Access Compliance Report Public Rights-of-Way (Curb Ramps)

Main Street: CAPRICORN_DR Cross Street: TERRASTAR_LN Location: NW

ADA ID: RPAT211101100505 Ramp Type: Type 4 - Parallel Initial Pass/Fail: Pass Overall Compliance: No Severity Score: 16

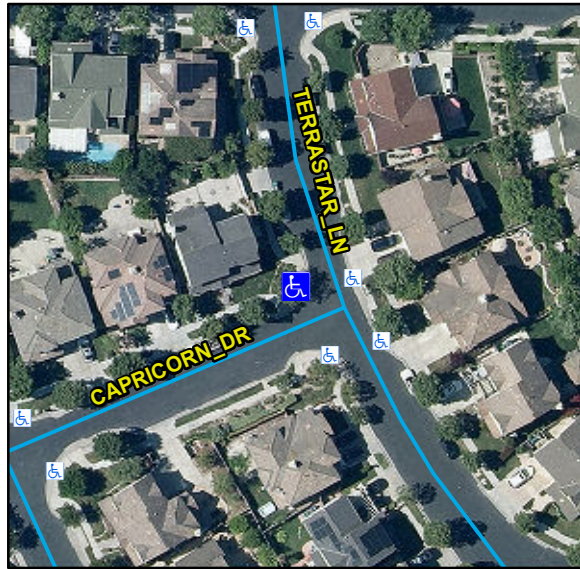
Compliance	Description	Data	Compliance	Description	Data
N/A	Ramp Length LT (in)	93	N/A	Ramp Length RT (in)	104
Yes	Ramp Width LT (in)	54	Yes	Ramp Width RT (in)	53
Yes	Ramp Run Slope LT (%)	0.6	Yes	Ramp Run Slope RT (%)	7.8
Yes	Ramp Cross Slope LT (%)	0.5	No	Ramp Cross Slope RT (%)	2.8
N/A	Landing Present	Yes	No	DWS Provided	No
N/A	Landing Length (in)	52	N/A	DWS Contrast	N/A
Yes	Landing Width (in)	70	N/A	DWS Length (in)	N/A
Yes	Landing Run Slope (%)	0.9	N/A	DWS Full Width	N/A
Yes	Landing Cross Slope (%)	2		DWS Offset Type	N/A
N/A	Landing Movement Obstructed?	No	N/A	DWS Offset Left (in)	N/A
	Landing Movement Type	Curb	N/A	DWS Offset Right (in)	N/A
N/A	Landing Shared	No			
N/A	Clear Space	Yes			
N/A	Clear Space To Crosswalk (in)	48			
N/A	Marked Crosswalk 1	No	N/A	Marked Crosswalk 2	No
	Crossing 1 Direction	S		Crossing 2 Direction	E
N/A	Marked Crosswalk 1 Width (in)	N/A		Marked Crosswalk 2 Width (in)	N/A
N/A	Ramp Inside Crosswalk 1	N/A	N/A	Ramp Inside Crosswalk 2	N/A

Crossing 1 Slope (%)	1.2		Crossing 2 Slope (%)	2.8
	Crossing 1 Cross Slope (%)	3.6		Crossing 2 Cross Slope (%)	1.1
Yes	Gutter Ponding	No	N/A	Curb Slope	11.1
Yes	Gutter Lip Height (in)	0		Road Run Slope (%)	2.3
No	Gutter Run Slope (%)	5.1		Road Cross Slope (%)	2.4
No	Gutter Cross Slope (%)	3.8	No	Perpendicular Joint Present	No
Yes	Overall Surface Condition	Acceptable			
	Cross Gutter Present?	No		Spandrel Present?	No
	Replace Cross Gutter?	N/A		Replace Spandrel?	N/A

Remove & Replace Curb Ramp With Two New Directional Ramps or Equivalent. Remove & Replace Gutter.
